JAN 29 2009

Subject: Draft Revised Long-Term Surveillance Plan for the Shirley Basin South, Wyoming,
UMTRCA Title II Site

**Long-Term Surveillance Plan
for the Shirley Basin South
(UMTRCA Title II) Disposal Site,
Carbon County, Wyoming**

Figure 2-5. Cross Section A-A' of the Shirley Basin South, Wyoming, Disposal Site

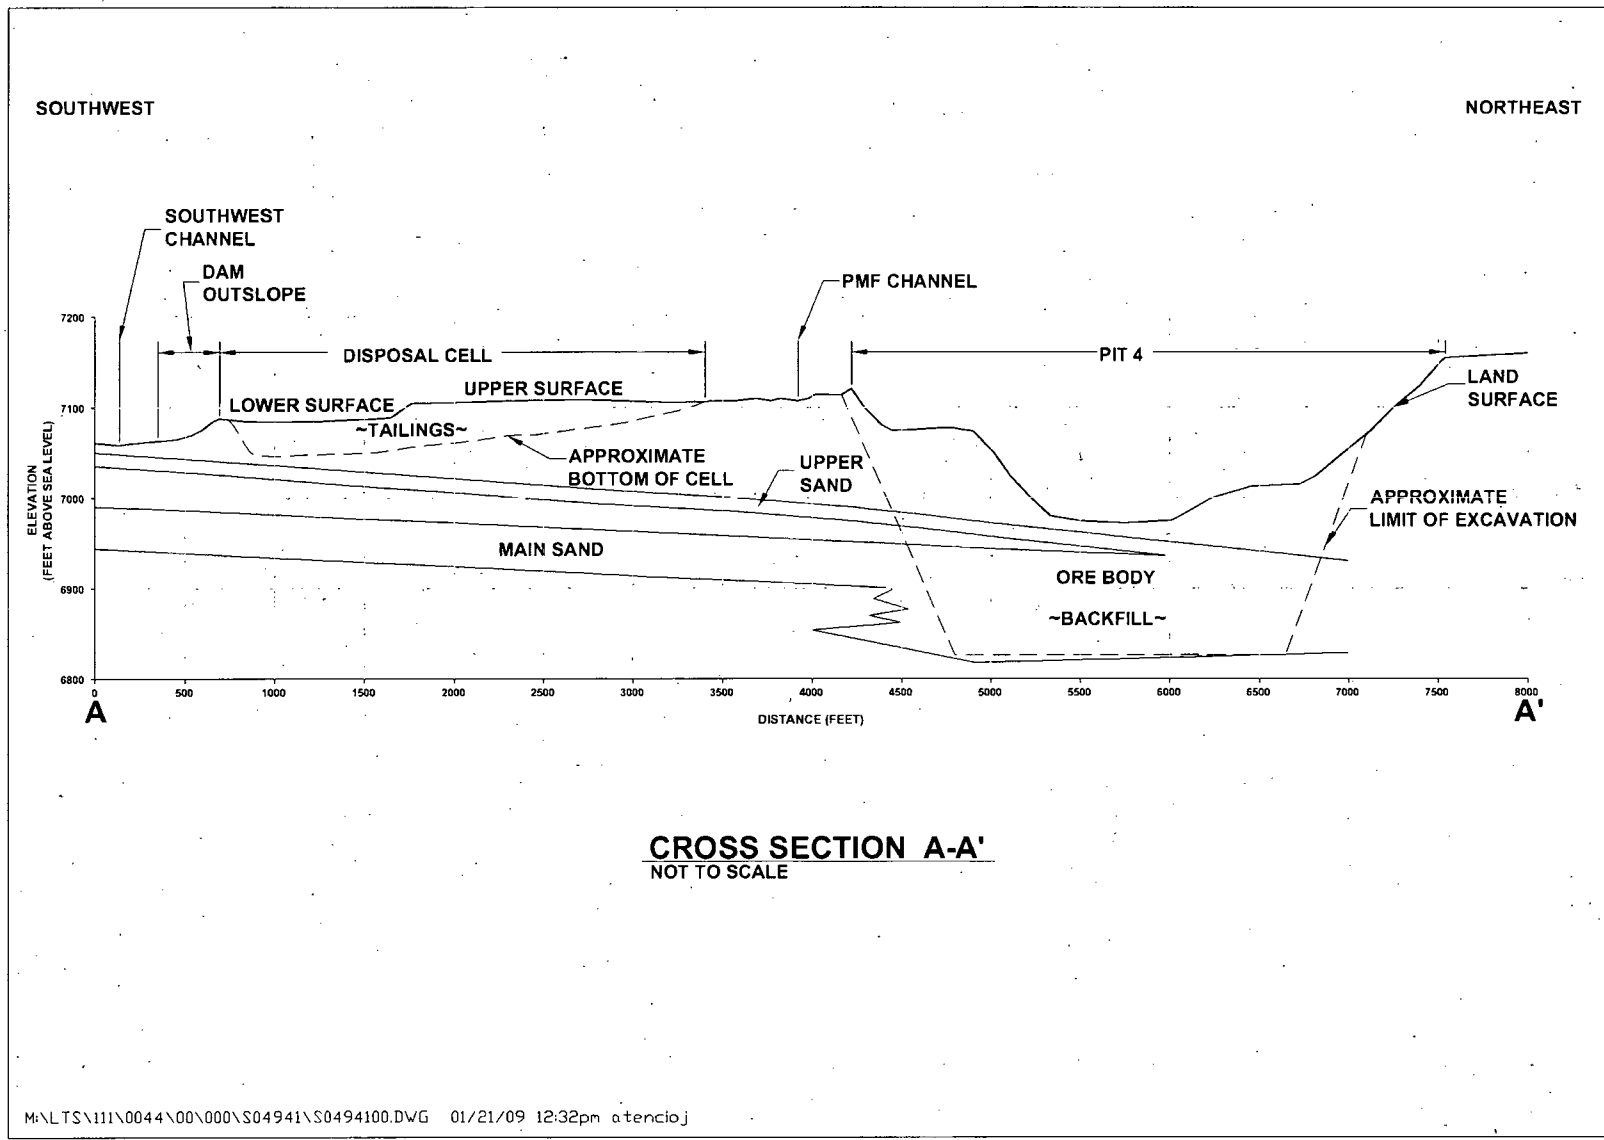
- Section 2.3.5 "Site Geology" was expanded based on the research and construction associated with installing the new monitor wells. Included is a new figure representing a cross section through the site (Figure 2-5).

Figure 3-2. Groundwater Monitoring Network at the Shirley Basin South, Wyoming, Disposal Site

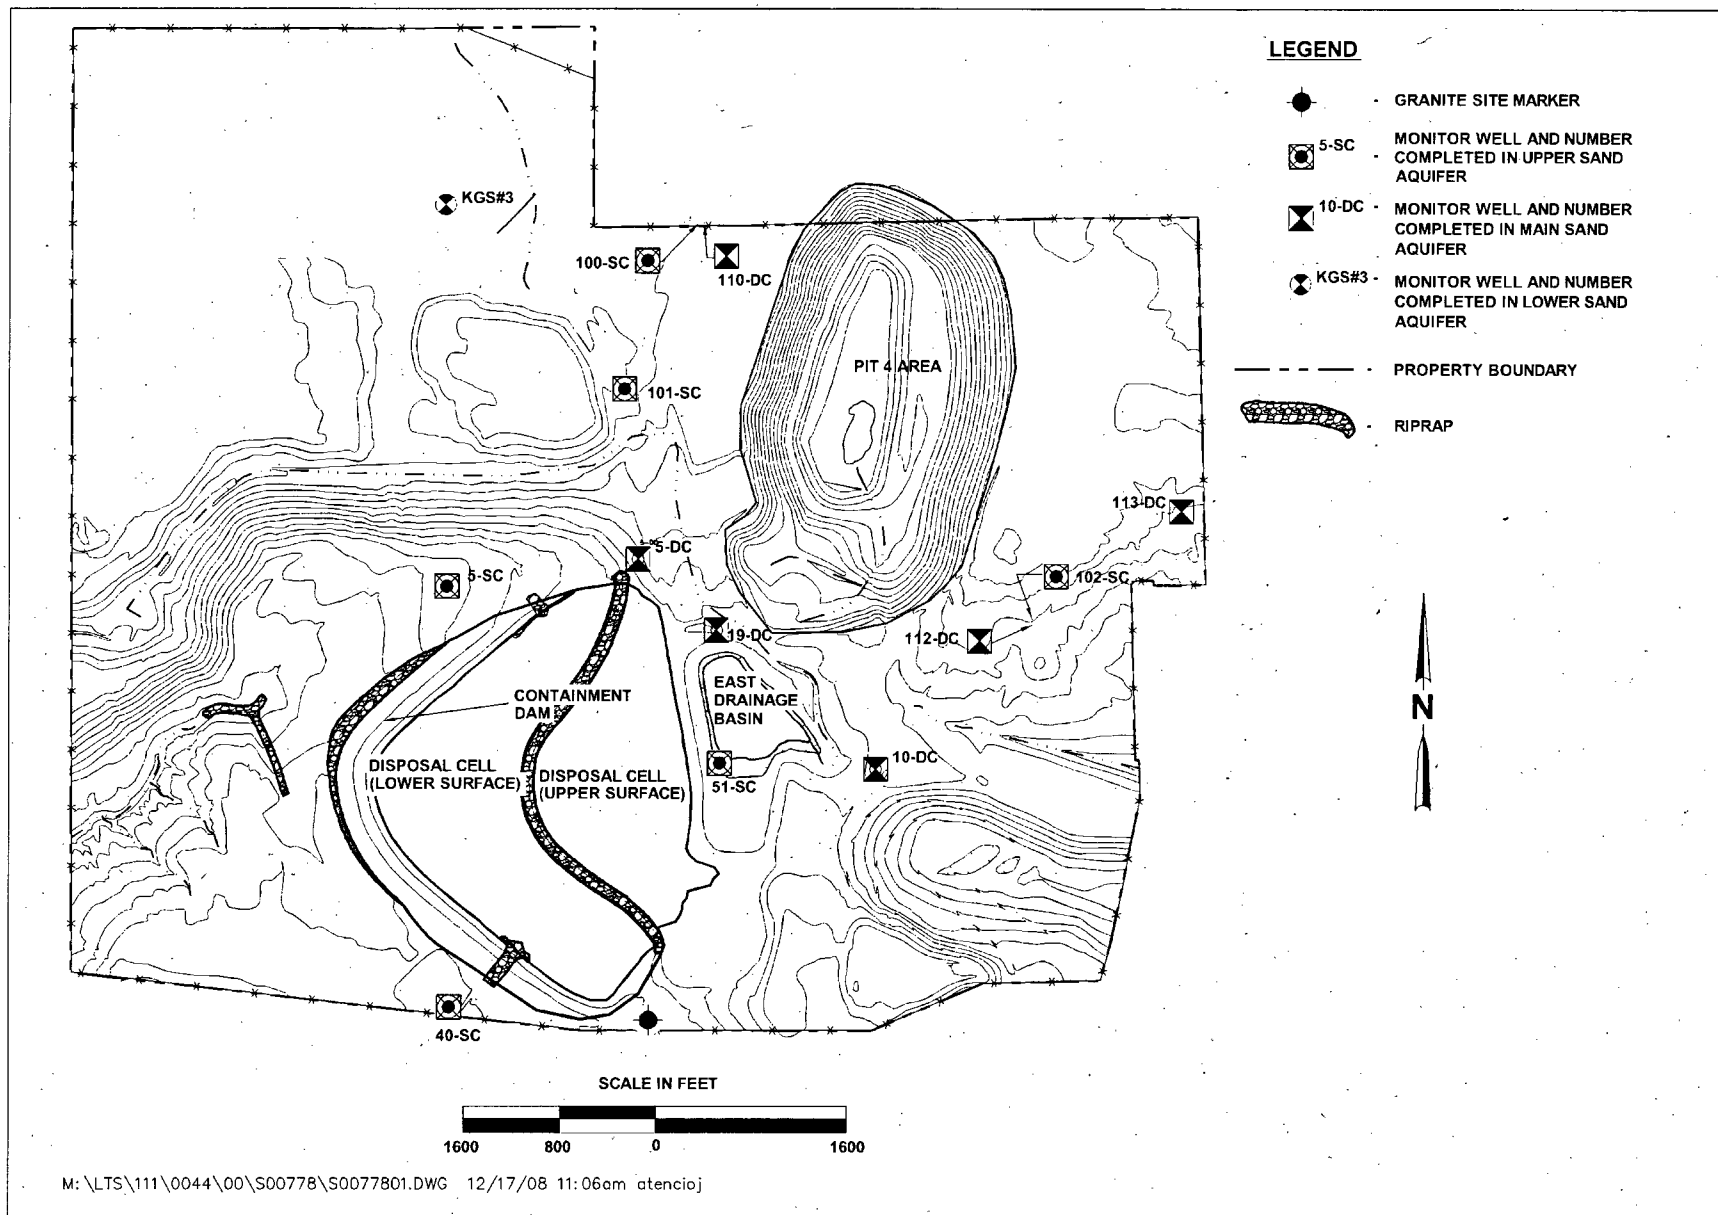
- Section 2.5 "Ground Water Conditions" was rewritten based on the research and construction associated with installing the new monitor wells.
- Section 3.7 "Environmental Monitoring" was rewritten to incorporate the results of the ground water monitoring evaluation. Several constituents, including radium-228 and cadmium, were determined to be naturally occurring and not good indicators of cell performance; therefore, DOE proposes that they be removed from the ground water monitoring program. DOE proposes to monitor the following constituents that are likely to be the best indicators of disposal cell performance: radium-226, thorium-230, uranium, chloride, nitrate, sulfate, and TDS. The respective ACLs and ground water protection standards for these constituents remain unchanged from the original LTSP.

- DOE determined that original well MW-54-SC, documented as representing the uppermost (Upper Sand) aquifer, is actually continuously screened through both the Upper Sand and Main Sand aquifers. To avoid potential cross contamination between the aquifers, DOE proposes to decommission the well. A replacement monitor well (MW-101-SC), screened in the Upper Sand aquifer, was installed near well MW-54-SC.

Based on the above evaluation, the revised monitoring program for cell performance will include analyses of chloride, nitrate, sulfate, radium-226, thorium-230, and uranium concentrations. Measurement parameters including electrical conductivity, pH, and water levels will also be obtained during sampling events. The locations of the monitor wells in the groundwater monitoring network are shown on Figure 3-2.
